PreciseFlex 400 robots with serial number label date range of 2507 – 2509 and serial label revision of 1A.

### Purpose of this TSB

This TSB notifies customers of error -3101 that may occur with the PreciseFlex 400 robots that were manufactured from July 2025 – September 2025. This notice provides instructions on how to edit the setup parameters to resolve the issue.

Figure 1: Factory Values for 10369 that cause -3101 Error

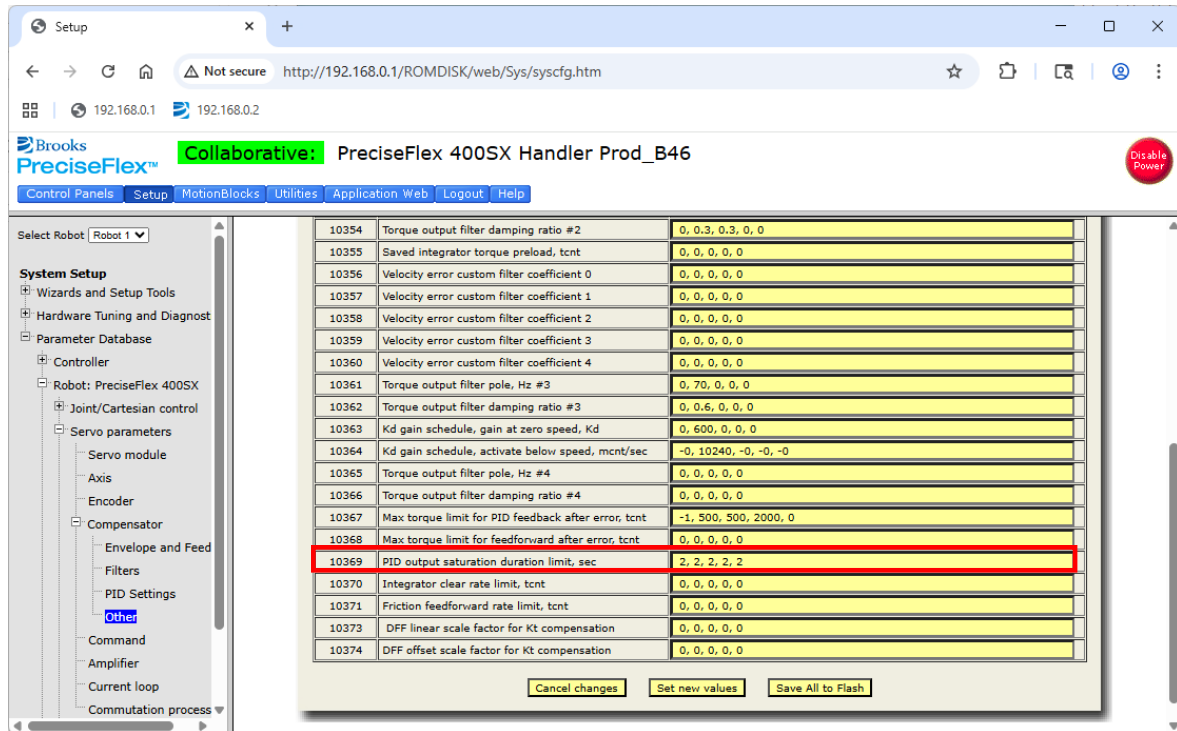
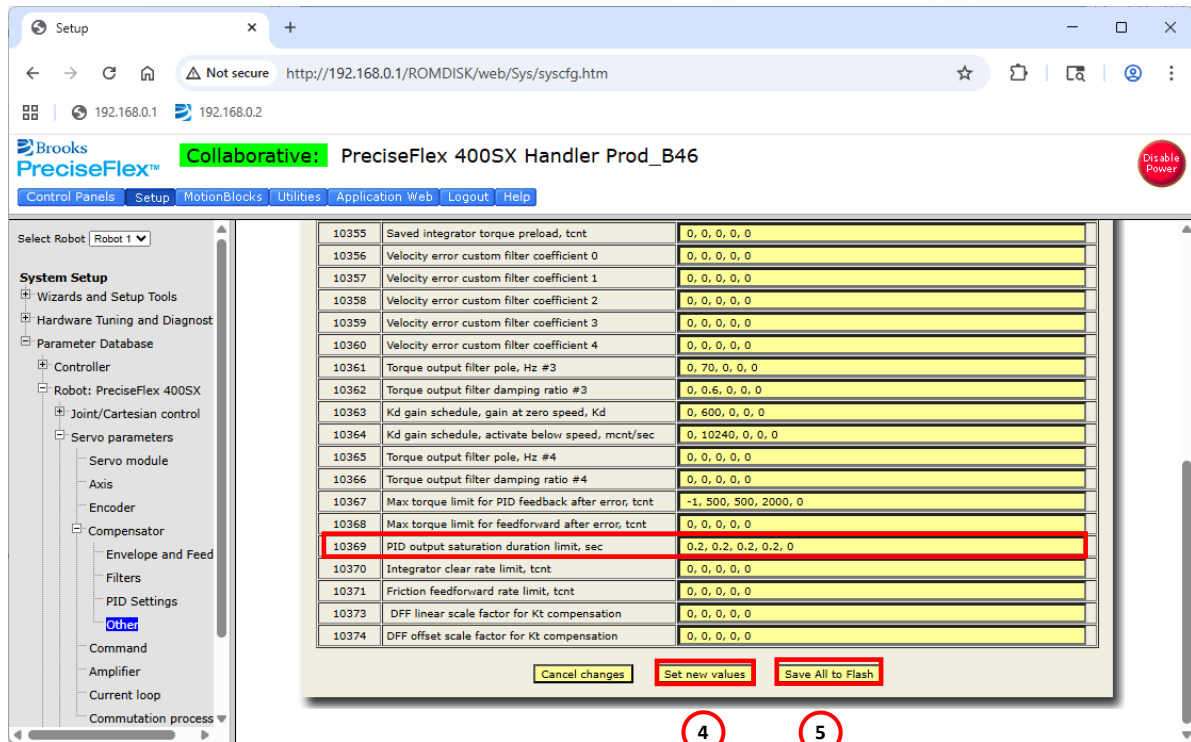
The problem is traced to incorrect parameters in the 10369 “PID output saturation duration limit, sec” field as shipped from the factory for PreciseFlex 400 robots manufactured during the timeframe of July 2025 – September 2025. Values as shipped from the factory were: 2, 2, 2, 2, 2

1. Access the web-based operator interface for the robot – screenshots on following page.
2. Navigate to: Setup>System Setup>Parameter Database>Robot: PreciseFlex 400SX (or PreciseFlex 400SXL)>Servo parameters>Compensator>Other and locate data ID “10369 PID output saturation limit, sec”
  - Figure 1 illustrates the problematic factory values of 2, 2, 2, 2, 2
3. Edit the values to be: .2, .2, .2, .2, 0
4. Select [Set new values]
5. Select [Save all to Flash]
  - Figure 2 illustrates the updated settings.

The issue has been corrected as of September 2025 with the release of new PAC files. The customer can fix the issue by manually updating the System Setup parameters for Data ID#10369 to be: 0.2, 0.2, 0.2, 0.2, 0.

Figure 2: Valid Values for 10369
